Project Name: Occidental Oil Shale – 751 Horizon Court – Dev. in H.O.

OCCIDENTAL OIL SHALE, INC., OFFICE BUILDING

REVIEW SHEET SUMMARY

Response to Review Sheet Summary dated October 15, 1981

SITE PLAN

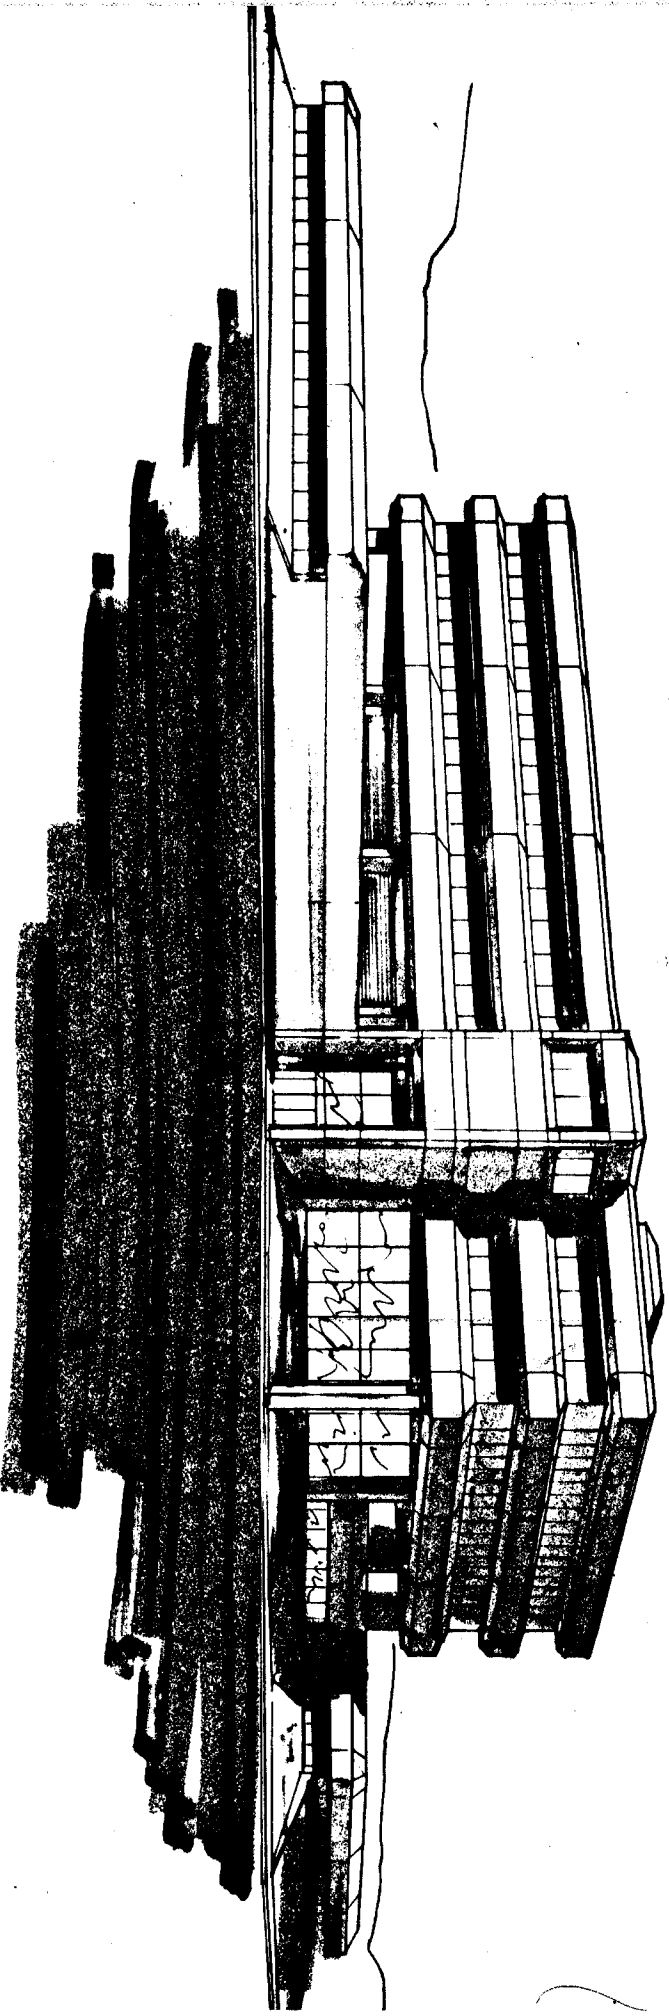
10/15/81	City Engineer	<p>I am currently reviewing detailed construction plans for Cathedral Bluffs Blvd.. My comments on those details will be by letter to ARIX. The City intends to improve Horizon Drive adjacent to this site in 1982. We hope to construct a new bridge across the Highline Canal this winter while the irrigation water is out. Design work has begun. Cooperation from the petitioner concerning details of the "Retention Pond" and drainage outlets near the south corner of the site will be appreciated and needed. We anticipate lowering Horizon Drive in this area. Their site plan looks good.</p>

Owner and ARIX will be happy to coordinate with City personnel in upgrading Horizon Drive in front of site. ARIX and the developer's engineers will provide any coordination necessary to facilitate site drainage through new construction.
